The Reid Supply Company

Mr. John Goetz, Chief
Hazardous Waste Section
Bureau of Waste Management
Forbes Field
Topeka, Ks. 66620

July 9, 1984

Below is Reid Supply Company's response to the KDHE-EPA Notice of Deficiency/Letter of Warning of June 15, 1984. The comments and concerns are addressed as they appear in the letter.

Figure 5

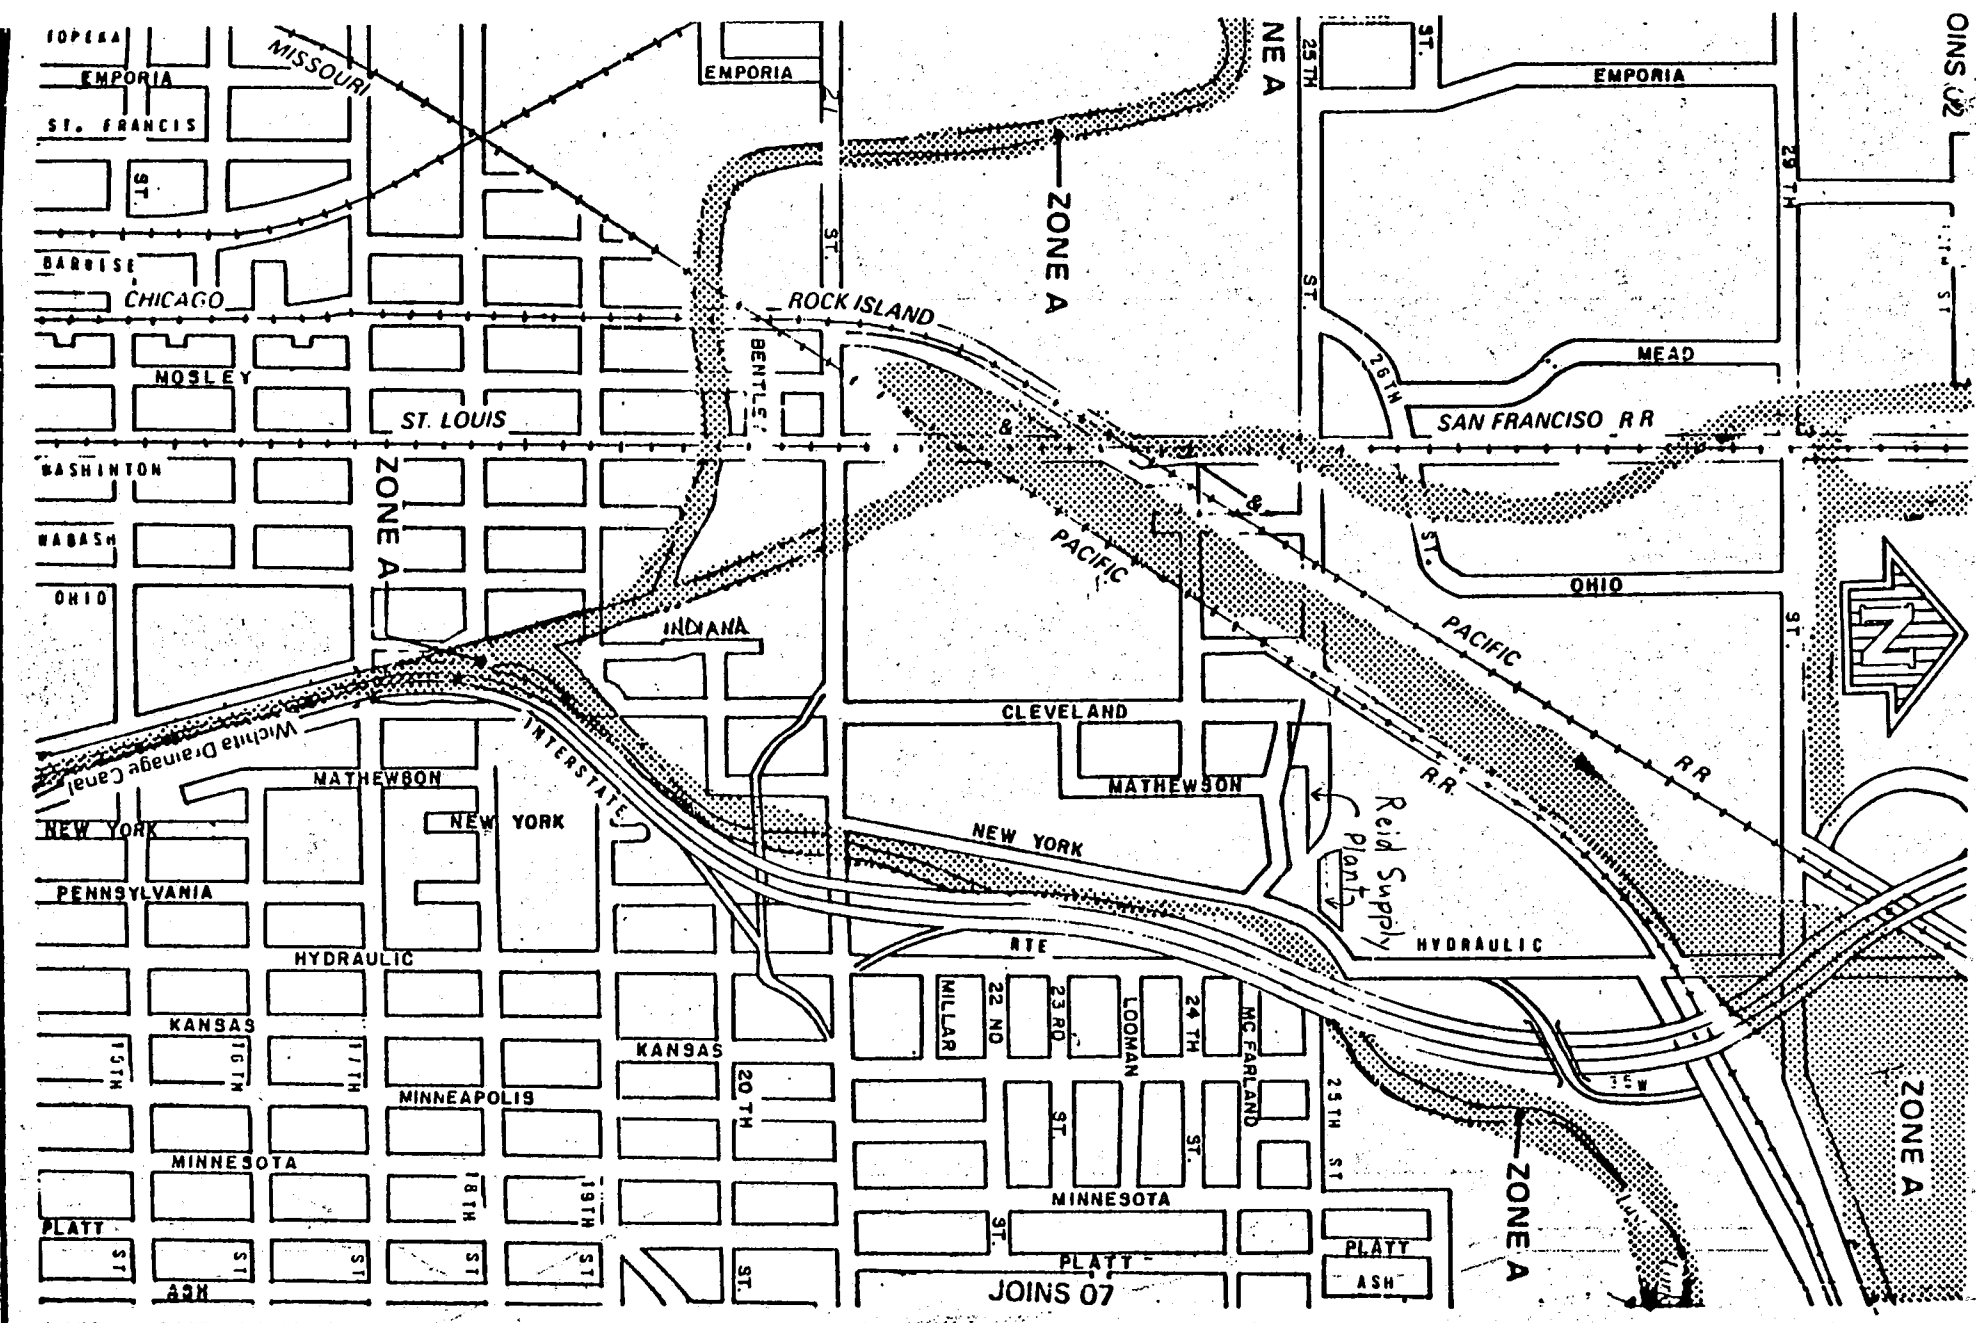
1. Rather than refer to the aerial photo, please see fig. 4 and 5 of the original Part B application (provided) for a letter from the City of Wichita Department of Engineering and the Flood Hazard Boundary Map showing that the Reid Supply Company facility does not lie within a 100 year floodplain. The canal shown on the aerial photograph is for flood control. Therefore, no barriers for drainage or flood control are necessary on site.
2. The facility map enclosed shows the facility boundaries marked by a line labeled "boundary". The boundary line becomes dotted to help show that the boundary still exists yet the properties of Reid Supply Company Plant and Trombold Industrial Park are still contiguous.

DIKED DRUM
STORAGE AREA
INDICATING
AISLE SPACE AND
GROUPING

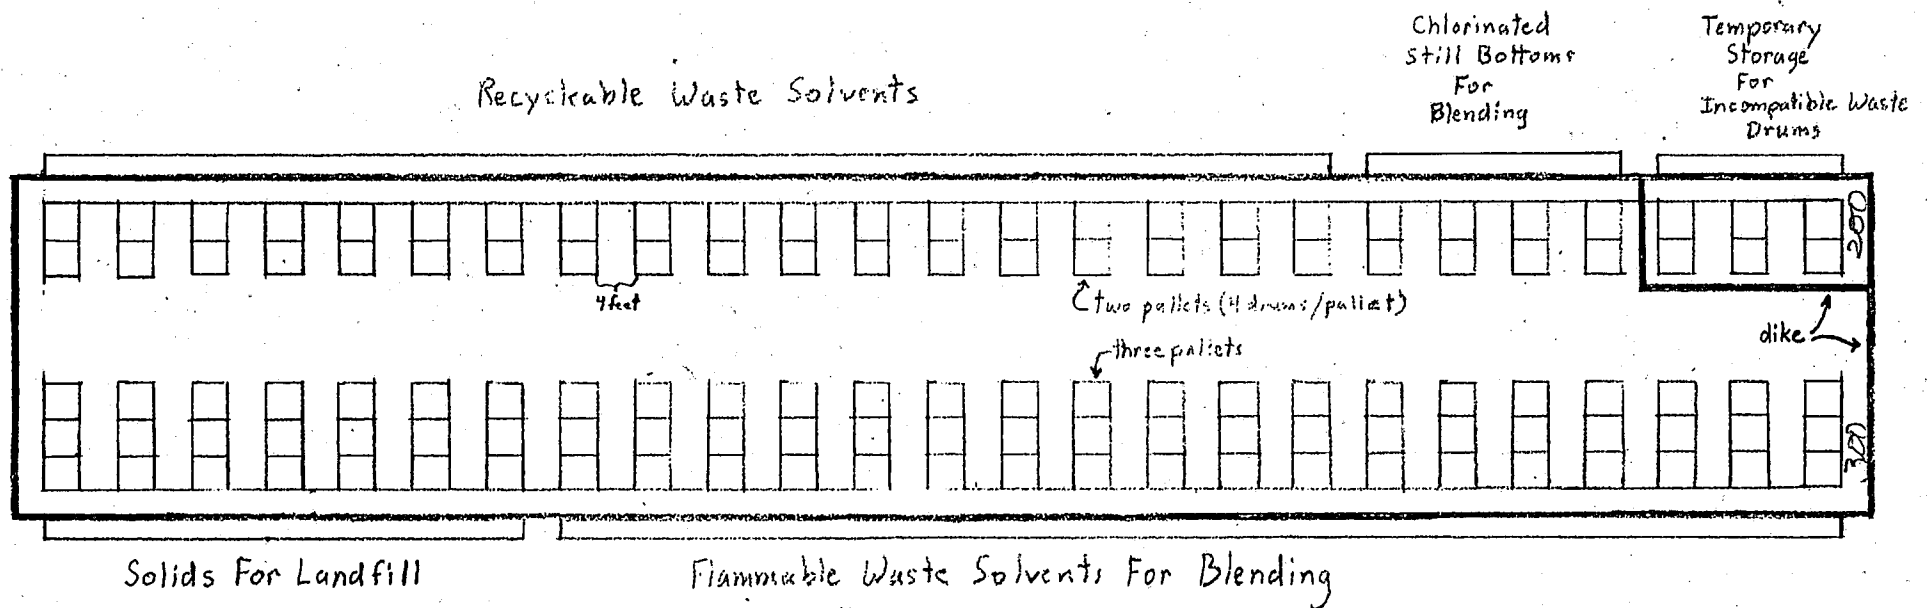
6. Rather than limit the storage of liquid hazardous waste drums to 400 drums and store drums containing solids outside the diked area which would rarely be close to 100 drums in number, the diked area will be 225 feet long instead of only 175 feet as stated in response 26 of the March 28, 1984, submittal. This will not significantly affect the waiver proposal of response 16 of the March 28, 1984, submittal because there will still be approximately a 110 feet buffer zone between the drum storage area and the lab. The "160 feet" of response 16 will be changed to 111 feet for the application. Please note the appropriate changes provided relative to response 26. The drum storage area will also be amended. This allows all hazardous waste drums to be stored in the diked area without limiting the number of liquid hazardous waste drums to 400.

7. This small diked area for incompatible or reactive waste located within the main drum storage area (see amended drawing showing aisle space and drum storage grouping) was proposed only to provide a temporary protected storage place if a few hazardous waste drums after fingerprinting are found to be reactive or incompatible with the other waste solvents. Storage of

the final dike will be three inches high and four inches wide. The engineering drawing of the drum storage area will be amended to show this. A temporary dike of bricks was constructed until a final decision concerning the buffer zone waiver is made. Upon approval of the waiver the permanent dike will be constructed of concrete.

float actuated air valve and liquid level control

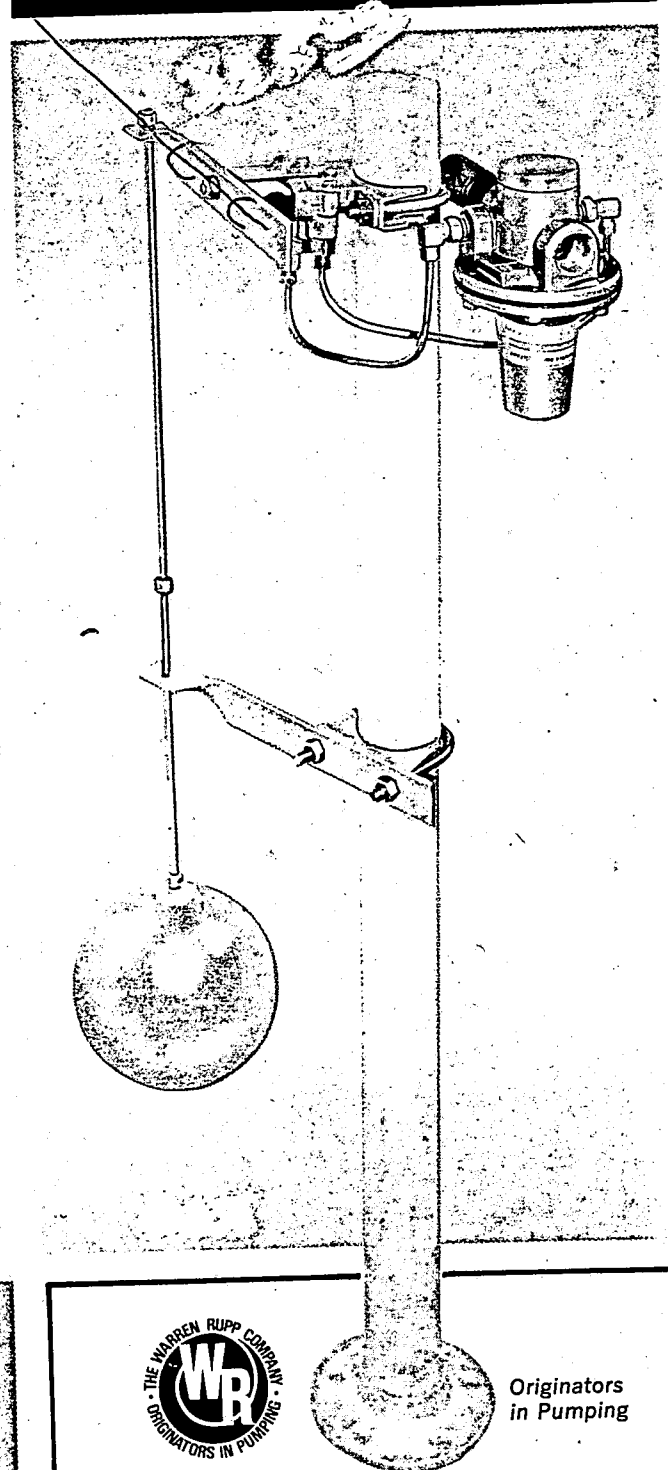
Enclosed is a diagram of the overfilling control equipment that fits in a 55 gallon drum. An overflow pipe feeds into this drum from both storage tanks and the feed level activates the valve and shuts off the air powering the diaphragm pump.

FACILITY MAP

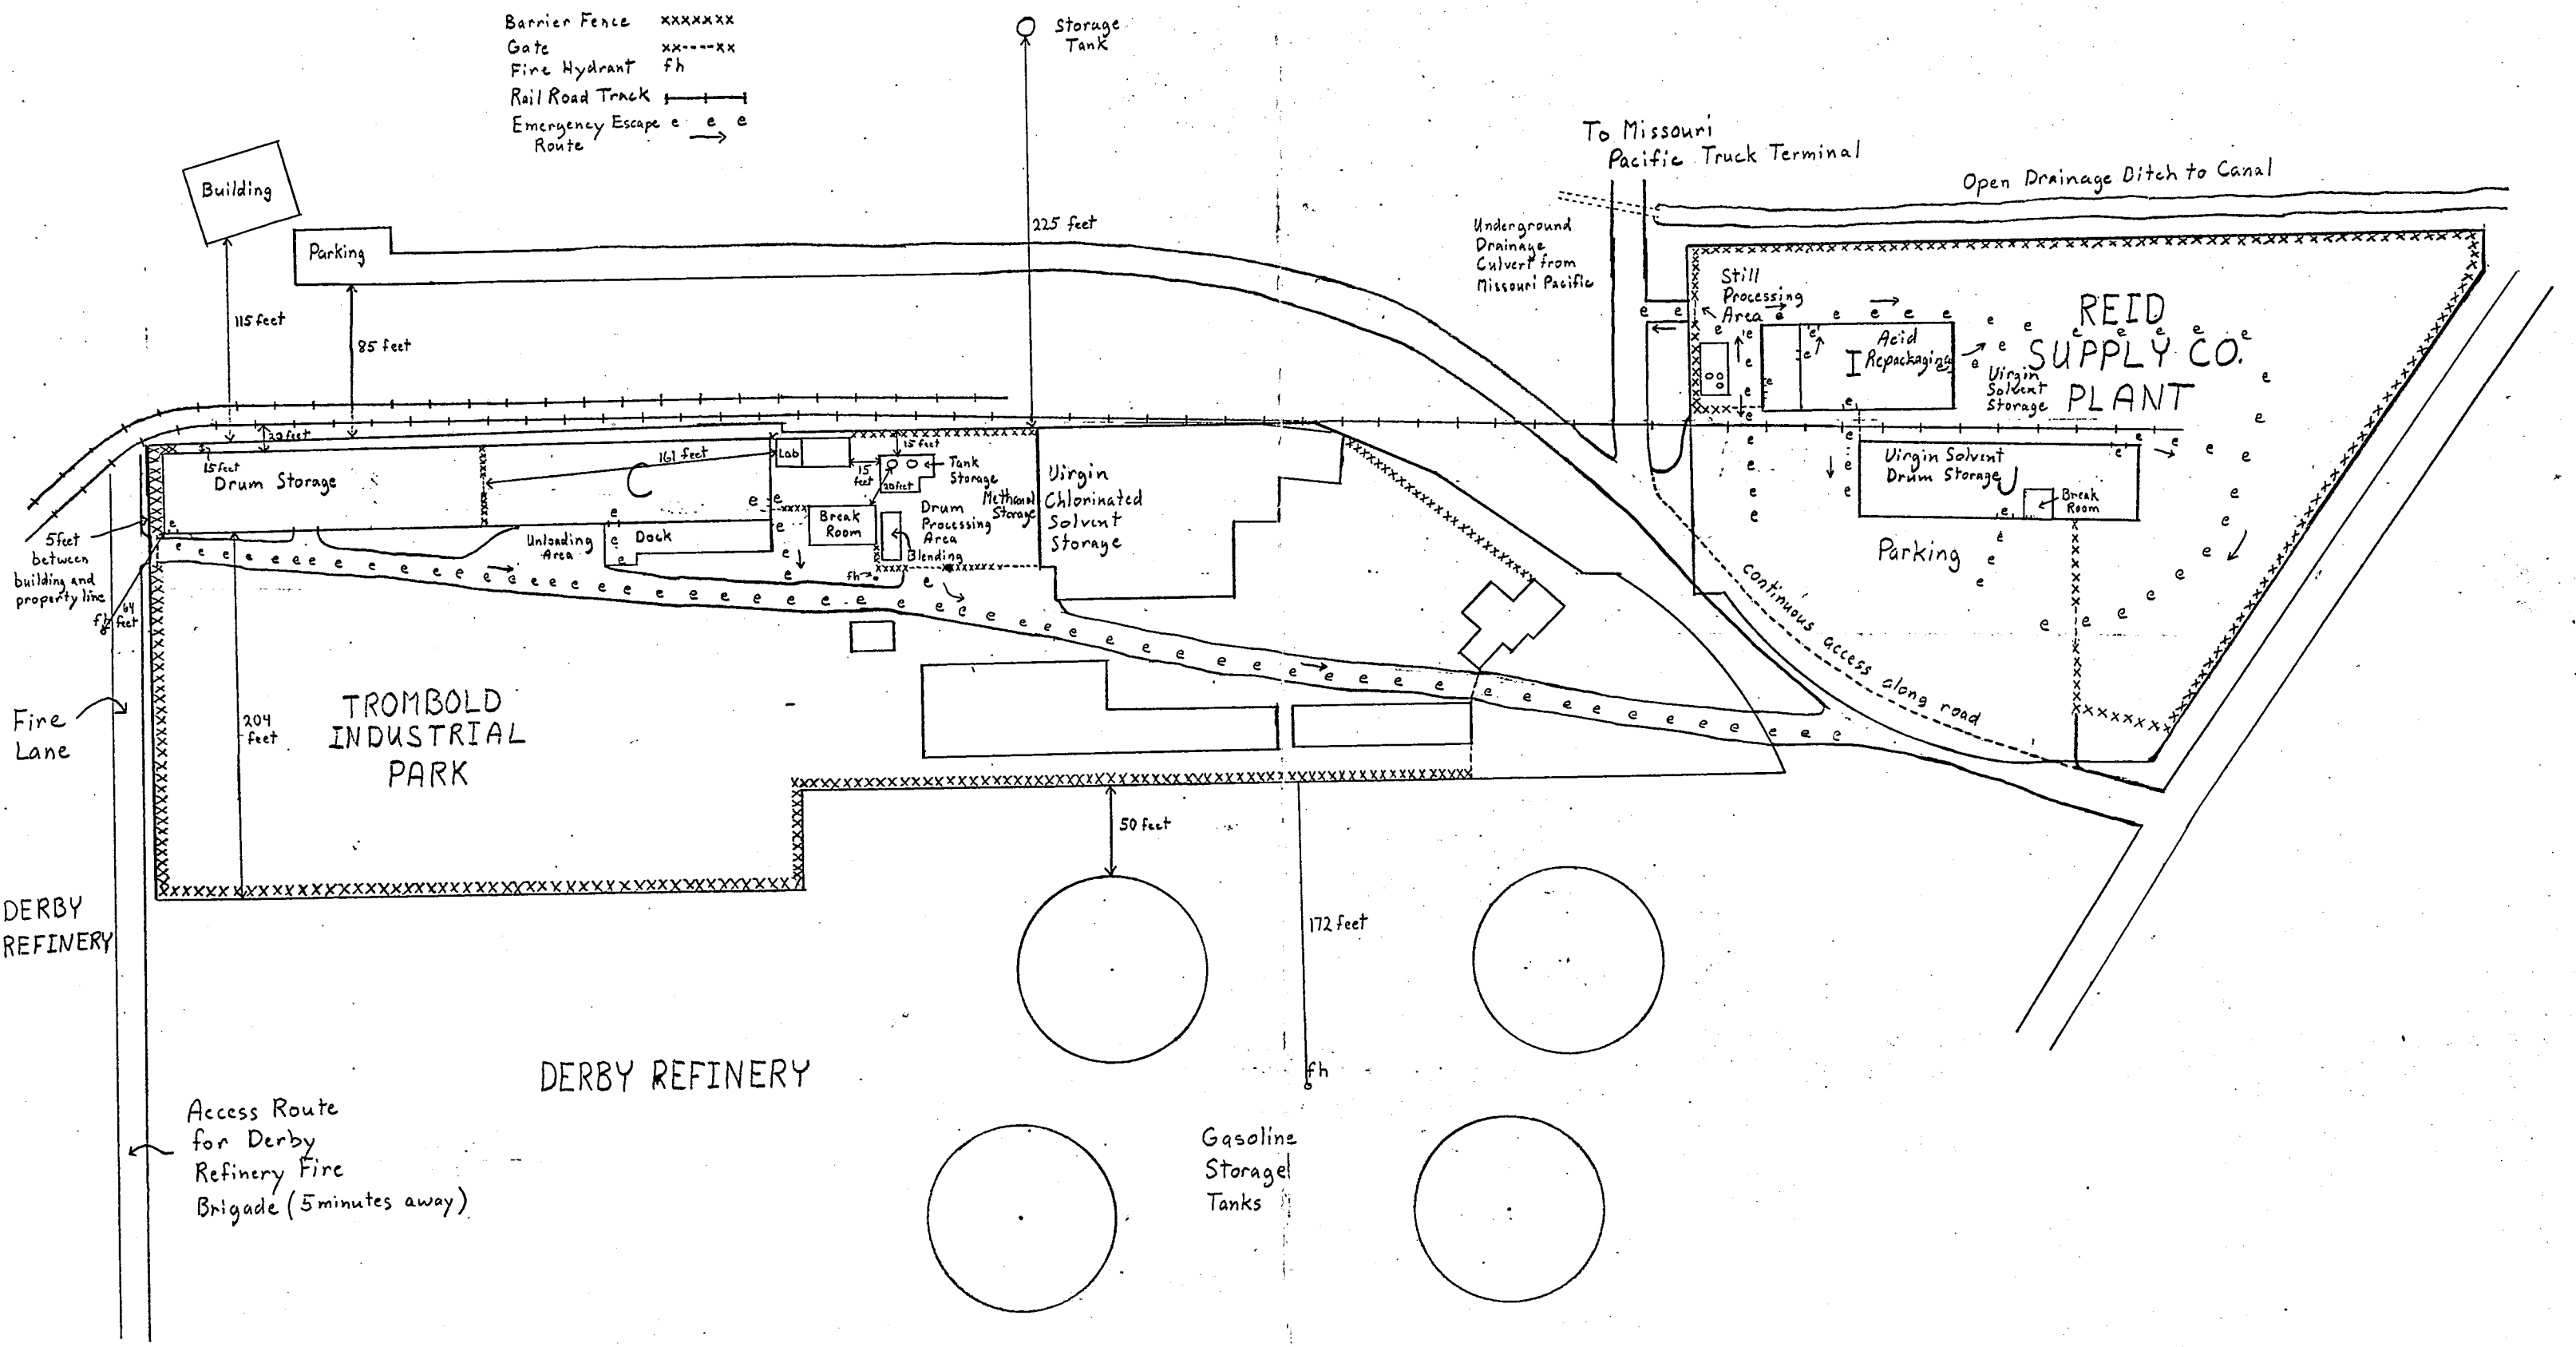
3. Please note that the facility map has traffic control signs marked.
